SOUTH CAROLINA ELECTRIC & GAS COMPANY

April 8, 1982

Subject: Virgil C. Summer Nuclear Station
Docket No. 50/395
Cold Overpressure Protection

South Carolina Electric and Gas Company (SCE&G) herein responds to the request by your staff regarding pressurizer PORV variable setpoints and adherence to 10 CFR 50 Appendix G limits, by providing a mark-up of FSAR Section 5.2.2.5. These changes will be incorporated into Amendment 31 to the FSAR.

Figure 5.2-15

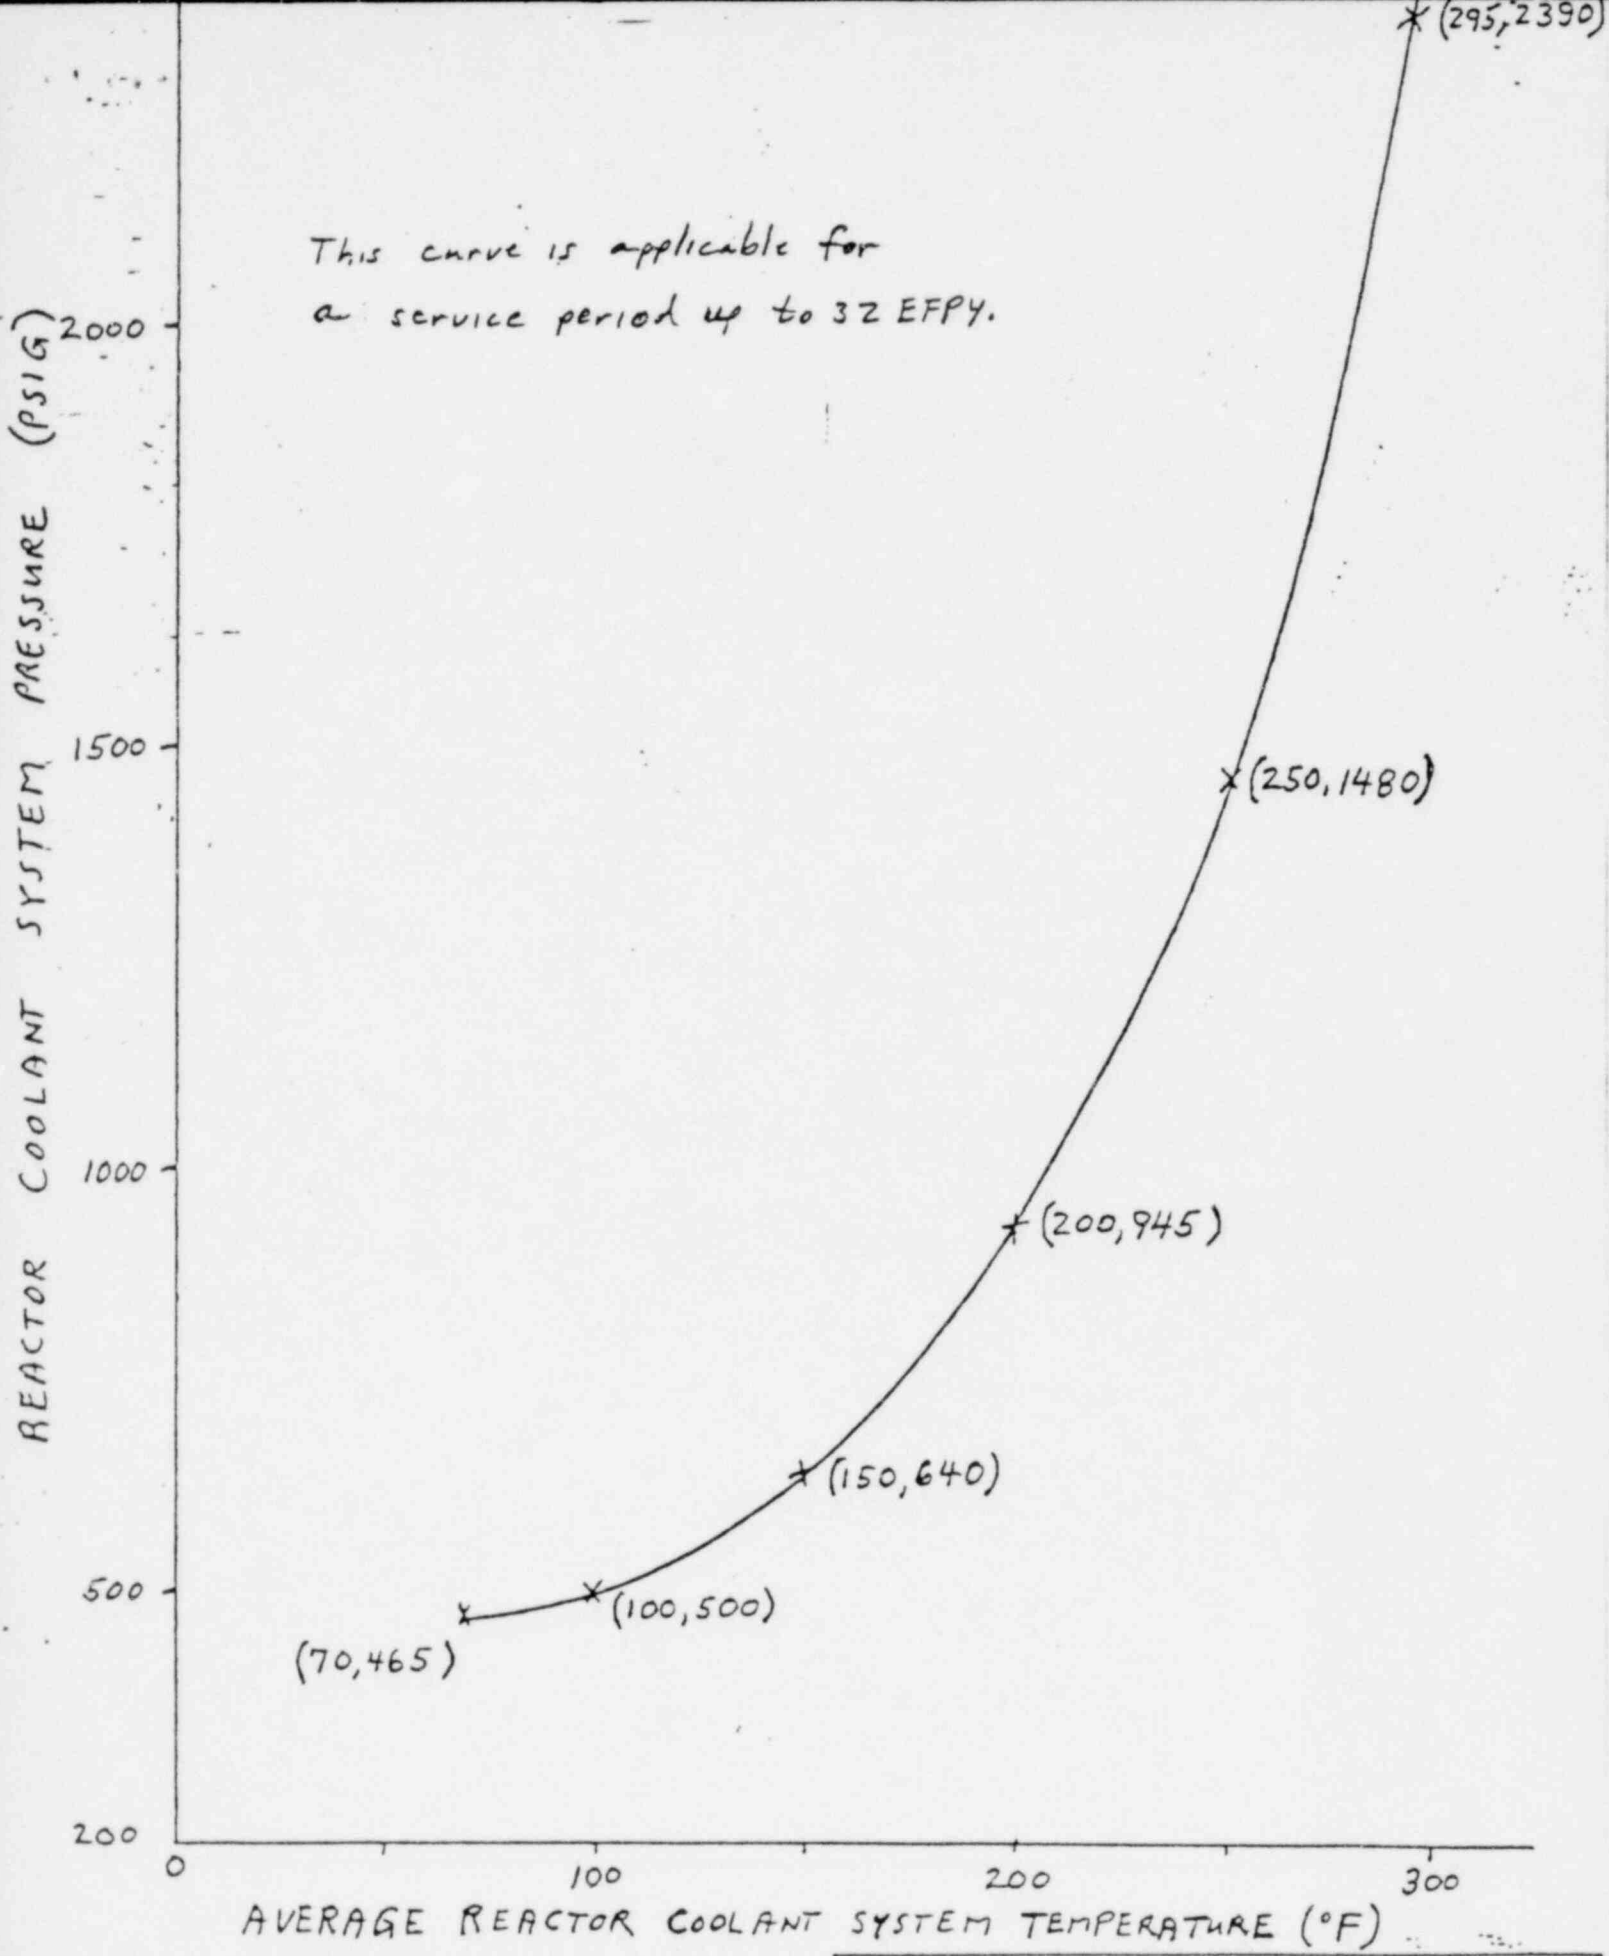
The OMS utilizes the PORVs with setpoints that vary depending on the average reactor coolant system temperature (T_{avg}). The lift settings are less than or equal to maximum setpoints defined by Figure 5.2-15.

Transient analyses were performed to establish a PORV lift setpoint program for the Overpressur Mitigating System (OMS) to be applied during shutdown operation of the plant. This program maintains reactor coolant system pressure within acceptable limits following all credible overpressurization incidents occurring in the plant during low temperature, water solid operation.

The mass input transient analysis was performed assuming the most severe event involving a single centrifugal charging pump. Specifically, a loss of air incident is postulated, whereby the flow control valve on the charging line fails open and, simultaneously, the flow control valve on the letdown line fails closed.

The heat input mechanism considered for analysis involved a RCS pump startup in one loop with a water solid condition and temperature asymmetry in the reactor coolant system, whereby the steam generators were at a higher temperature than the remainder of the system.
